September 30, 2015

Re: Site Specific Investigation
Pope Springs Wellfield
Technical Review

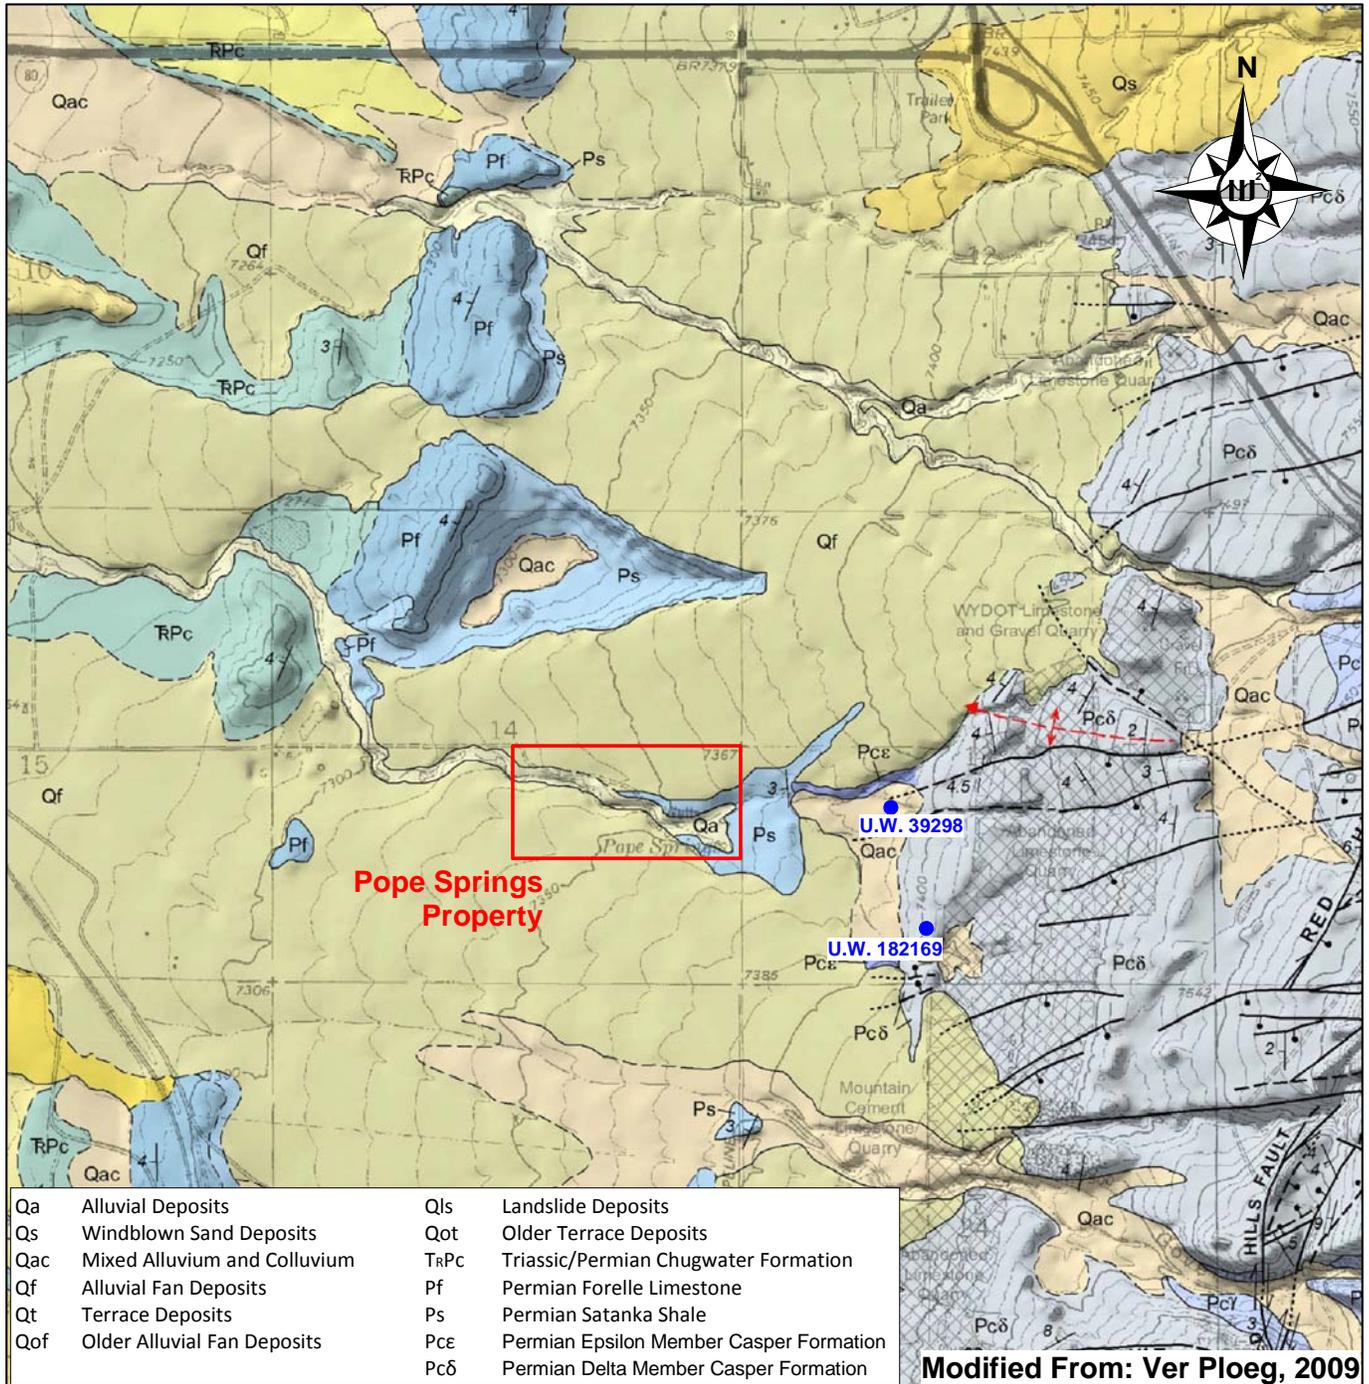
Some of the lithologic units shown on Trihydro's geology map (Figure 1) are difficult to read and discern. The color of the lithologic units on the map appear to be more washed out than the associated color blocks in the map legend. This makes it difficult to correlate between the legend and the map. Figure 1 was constructed by Trihydro utilizing the geologic map prepared by Alan J. Ver Ploeg as the background (Ver Ploeg, Alan J., 2009, Revised Geologic Map of the Laramie Quadrangle, Albany County, Wyoming, Wyoming State Geological Survey, Map Series 50. A copy of a portion of Ver Ploeg's map with the City of Laramie Pope Springs acreage called out is shown on the following page. The color scheme of this map makes it a little easier to distinguish the different mapped lithologic units.

One item that was researched and discussed in later sections of Trihydro's SSI, but not listed in this section of their report, were the State Engineer's Office completion records for the 47 wells within approximately ½ mile of the subject property area. A review of the statement of completion records for these wells reveals that "lost circulation" and/or "fractured/broken sandstone" was encountered in two of these wells – the Strom #1 well (U.W. 39298) and the Beardog #1 well (U.W. 182169). Lost circulation is typically an indication of very permeable

zones which in this area would be primarily from fractures and voids. The locations of these two wells are shown in the figure below.

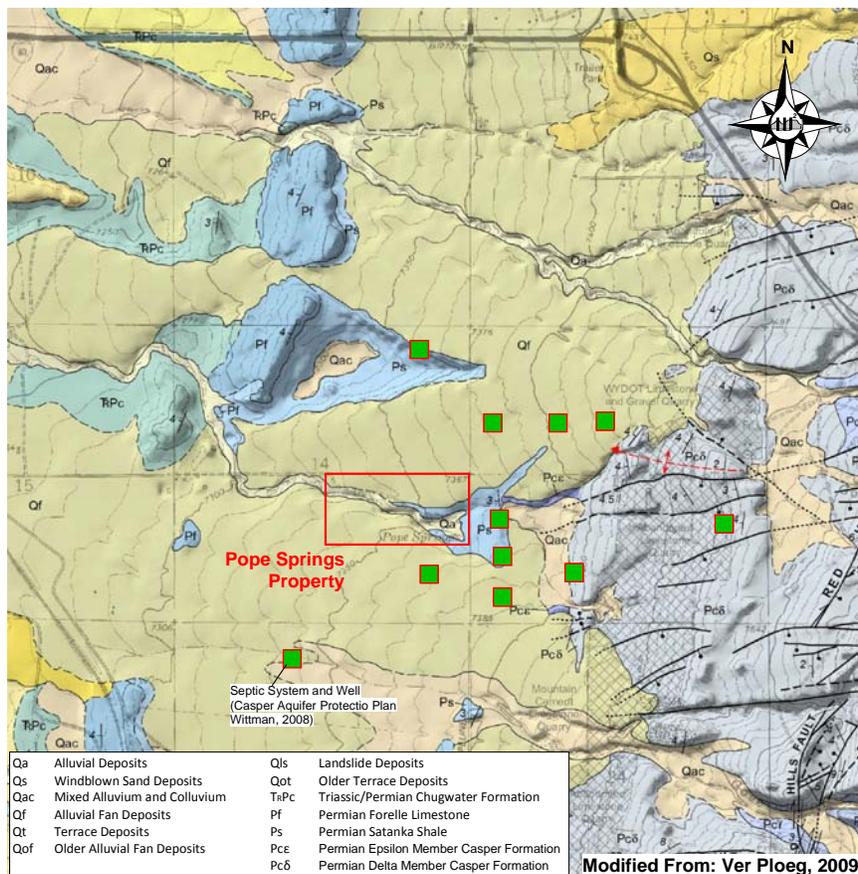
The SSI prepared by Trihydro indicates that the only planned improvement for the Pope Springs Wellfield property is to construct a chain link security fence around the immediate wellfield facilities. The two fencing options were shown on figure 2 in the Trihydro SSI report. This figure serves as the site plan to satisfy the requirements of the City of Laramie's Unified Development Code, subsection 15.08.040.A.8. The ground contour information specified was not presented, and based on the proposed improvements is not essential information. The SSI report did present a surface geology map that has the Laramie USGS 7.5 Minute topographic map as a background (Figure 1). However, the contour interval for this figure is 50 feet and provides only a very general definition of the topographic conditions on the eastern half of the Pope Springs Property. More complete contour information for the wellfield is shown in the figure on page 2 of this review letter report. The contour interval for this figure is 10 feet.

In general we agree with the concept presented in the SSI report that the information provided is adequate to demonstrate the proposed development plans for this parcel of land. However, we feel it would be beneficial to the City to include some of the requested information such as a topographic map, a discussion of the existing land use practices in the area and some general

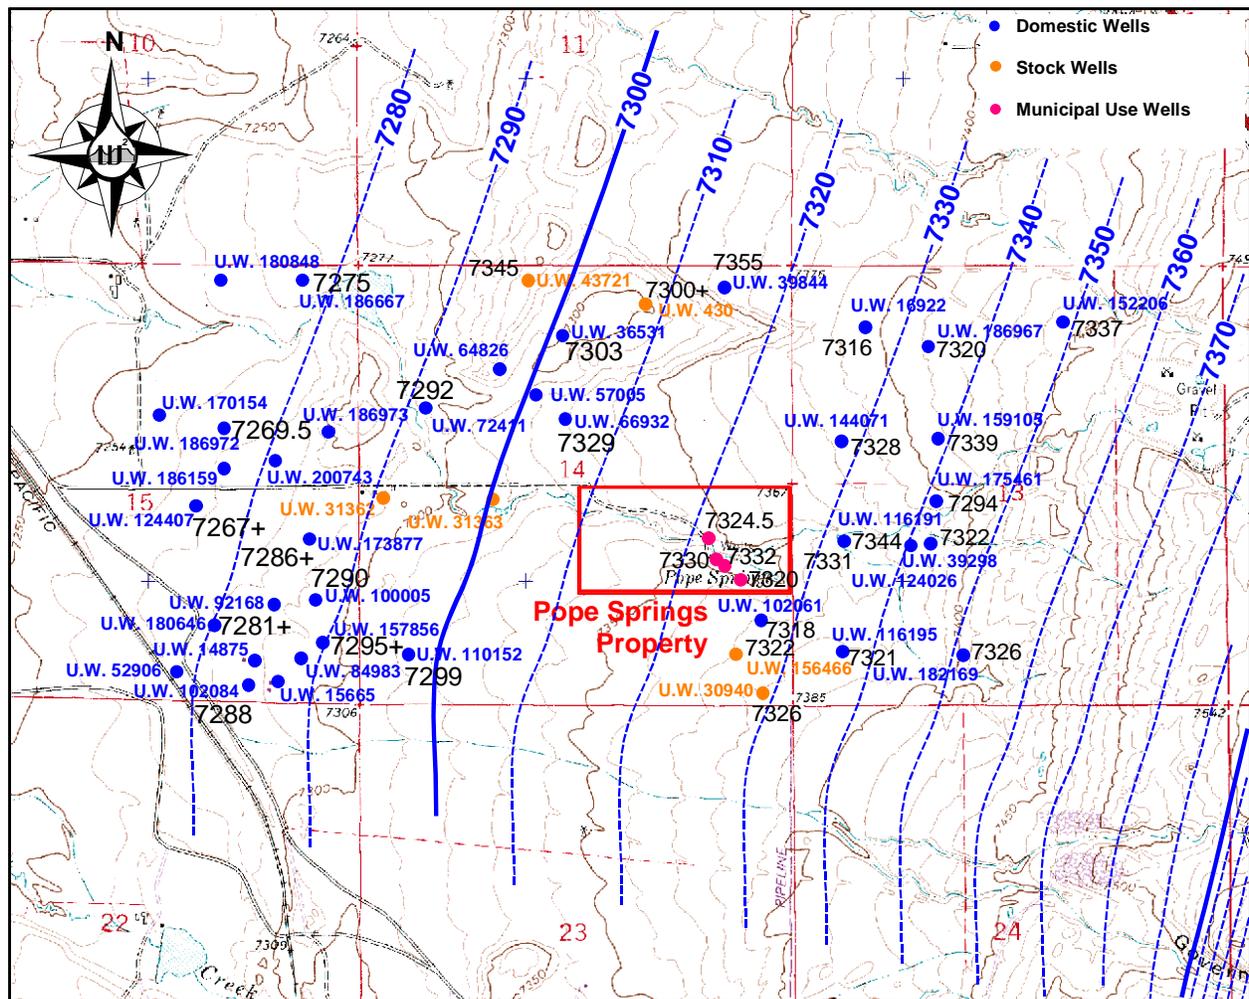
The figure below is the geology map of the area (Ver Ploeg, 2009) with the locations of the wells and septic systems in the area of Pope Springs Property. These septic system/well locations were transferred to this map from Figure 4-2a from the Casper Aquifer Protection Plan (Wittman, 2008). The Casper Aquifer Protection Plan identifies eleven (11) septic systems that are cross-gradient or up-gradient from Pope Springs. This figure shows that most of these septic systems and wells are located in areas that appear to have been structurally disturbed based upon their location with respect to the mapped faulting in the area and their position with respect to these mapped faults and the Pope Wells which are known to have encountered fractures in the Casper Formation. The location of these septic systems in these fractured areas will increase the potential for conduit flow and the rapid movement of potential contaminants through the aquifer. We agree with Trihydro's assessment that due to limited number of developed acreages in the area, these systems due not present a substantial threat to the aquifer. Studies have shown that both viruses and bacteria are effectively removed within the first 2 to 3 feet of soil beneath the leach field. With respect to an increased nitrate concentration from these few septic systems, it is not anticipated that the nitrate level will increase noticeably because of the dilution of the leachate in the Casper Aquifer. However, it should be noted that

WWC in their City of Laramie Water Supply Master Plan – Level 1 Report (1995) reported that there is “excellent hydraulic connection” between the Pope Wellfield and Soldier Springs. It is believed that this communication is most probably along the Red Hills Fault system located approximately 1¼ miles east of Pope Springs. Most of the existing domestic wastewater systems are located west (down-gradient) of this major north-south trending fault system. If development does extend eastward over the Red Hill fault area, the contributing number of septic systems impacting both Pope Springs and Soldier Springs would increase and the benefit of dilution will become more compromised.

1. Review the wells and septic systems in the area where conduit flow between these systems and the Pope Springs wellfield is very likely. A review of the figure on page 5 of this SSI Review letter indicates that there may be as many as 6 septic systems and several wells that are in potential conduit flow areas.
